CALVERT CLIFFS
NUCLEAR POWER PLANT

SUBJECT: Calvert Cliffs Nuclear Power Plant
Unit Nos. 1 & 2; Docket Nos. 50-317 & 50-318
Request for Additional Information Regarding Generic Letter 2004-02

**REQUEST FOR ADDITIONAL INFORMATION REGARDING
GENERIC LETTER 2004-02**

Figure A
CCI Generic Vortexing Analysis

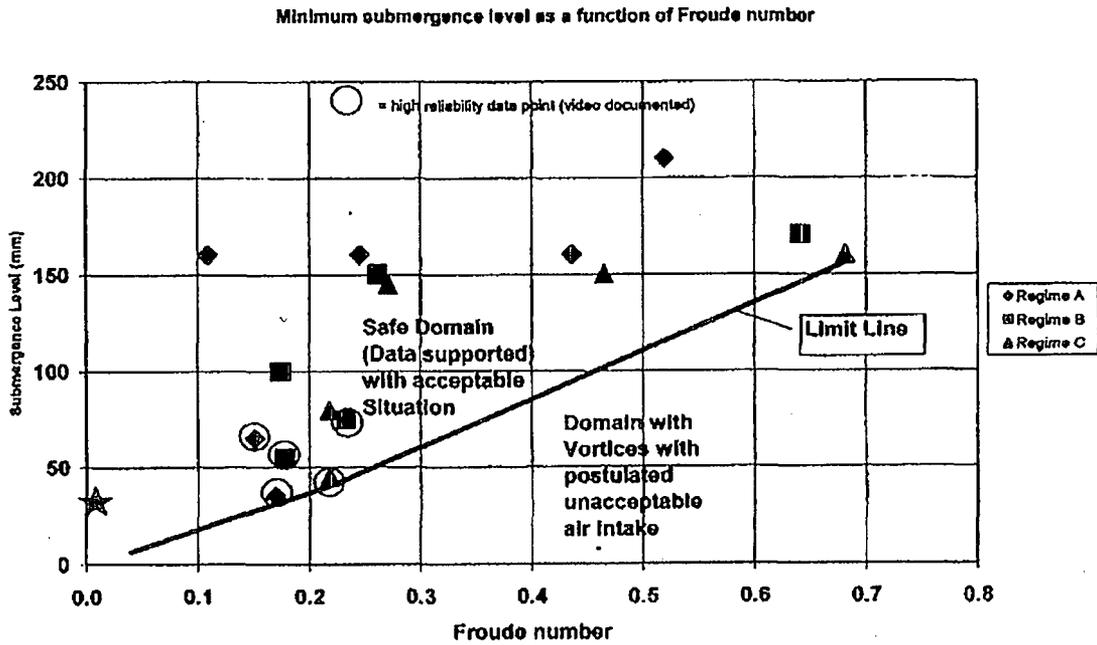
- a. *The licensee's response to section 3f4 indicated that testing was conducted at about 4 inches submergence and that flow rates during clean strainer testing ranged from 80% to 500% of the nominal design flow rate. Section 3f3 and the response to RAI 14 stated that testing was conducted at 1 inch and about 6 inches. Please explain whether observation for vortex formation was conducted at the minimum submergence of 1 inch. If so, please state what flow rates were used during this testing.*

- d. *If testing was not conducted at the minimum submergence and maximum flow rate, please provide additional details on how it was concluded that vortex formation would not occur.*

Figure A is a replica of the CCI graph obtained from Reference 11. The star plotted on this figure represents the condition of the Calvert Cliffs strainer for the case where the submergence is approximately 1 inch (0.0298 m) and the approach velocity is 0.027 m/s. This velocity represents the velocity of the fluid entering the module closest to the pump suction (i.e., peak velocity), and is obtained using the system of hydraulic resistance coefficients of the strainer internals described in the response to RAI 16. This velocity is obtained using the strainer flow rate of 5000 gpm multiplied by approximately 6.6 (see response to RAI 19e). As seen on Figure A the data point representing the minimum submergence condition at the nominal strainer flow rate of 5000 gpm is far to the left of the limit of unacceptable conditions, and is well inside the “Safe Domain.” Figure A thus demonstrates that no significant vortexing activity would occur under these conditions.

Figure B
CCI Generic Vortexing Analysis

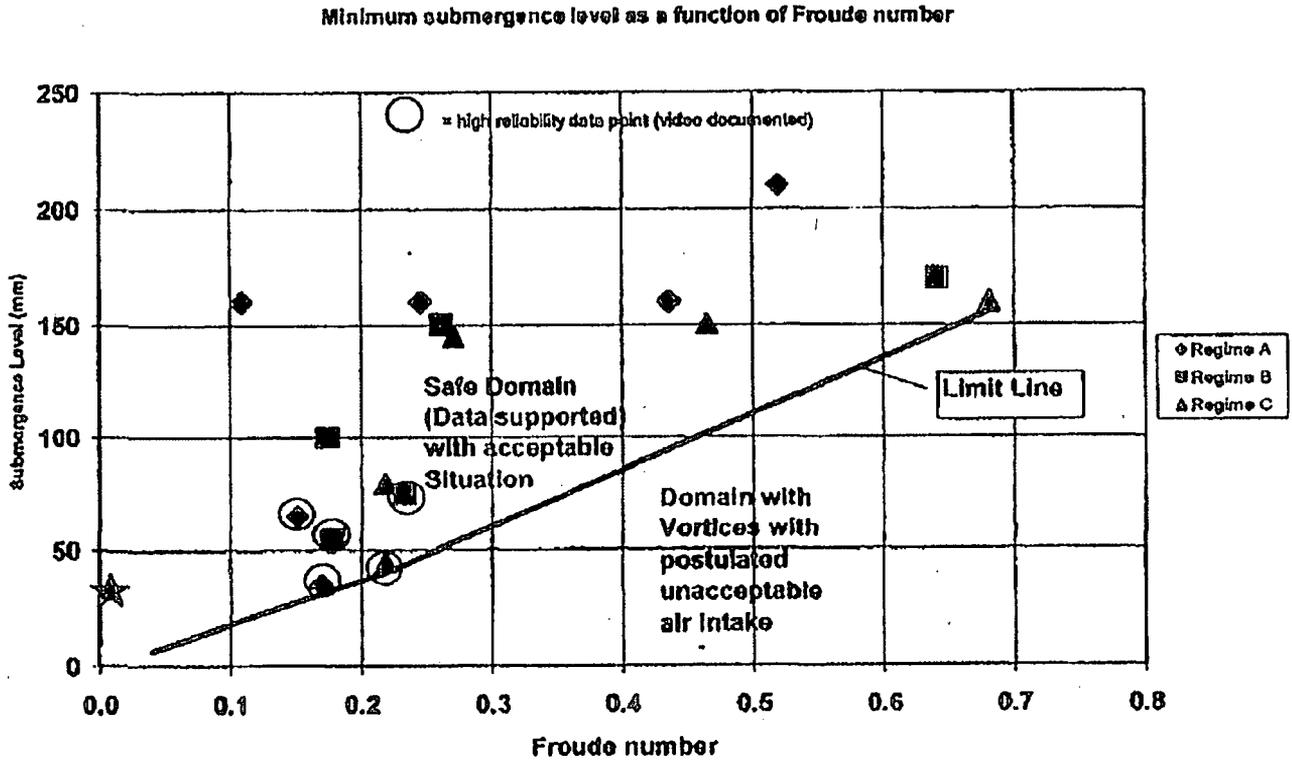
- b. *Please provide the maximum flow rate attained at each submergence level during testing.*
 - c. *Please state the maximum postulated flow rate through the strainer nearest the pump suction, and explain whether the maximum flow rate during testing bounds this value.*

- c. The maximum postulated flow rate through the strainer module nearest the pump suction is approximately 6.6 times greater than the nominal strainer flow rate. This equates to a velocity of 0.027 m/s. The maximum flow rate during testing of 27.0 m³/hr does bound this value. This peak flow rate was evaluated using Reference 11 (see response to RAI 17a), and was used in the head loss testing during the initial fiber and particulate debris additions.

condition still results in being in the "Safe Domain" for vortex formation (see Figure B). Therefore, it was concluded that vortex formation would not occur even for the peak velocity at minimum submergence if a LPSI pump failed to turn off upon receipt of a RAS.

Figure C

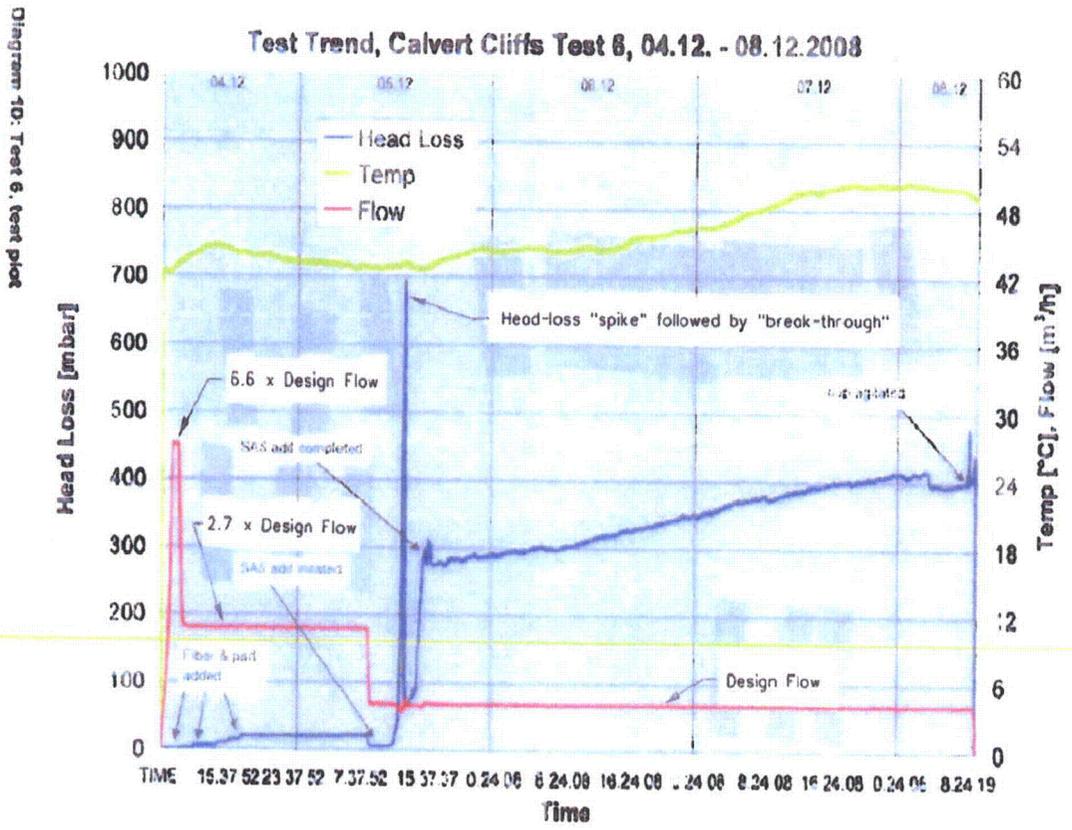
- e. *Please provide the flow rates used during the testing and the basis for any changes in flow rates during testing. (e.g. why was flow rate reduced after non-chemical debris addition and before chemical precipitate addition?)*

Figures C and D are Figures 3o2.26-2 and -3 (Reference 1) which have been annotated to show the flow changes described above. As described in RAI 19g, Figure 3o2.26-1 is no longer applicable due to a plant modification completed in March 2010. Note that some of the intermediate flows used in the test were not in effect for much more than 15 minutes. Compared to the time scale used in the head loss plots of Figures 3o2.26-2, -3 (Reference 1) this is a short period of time, and therefore, the Figures may not appear to reflect all flow changes.
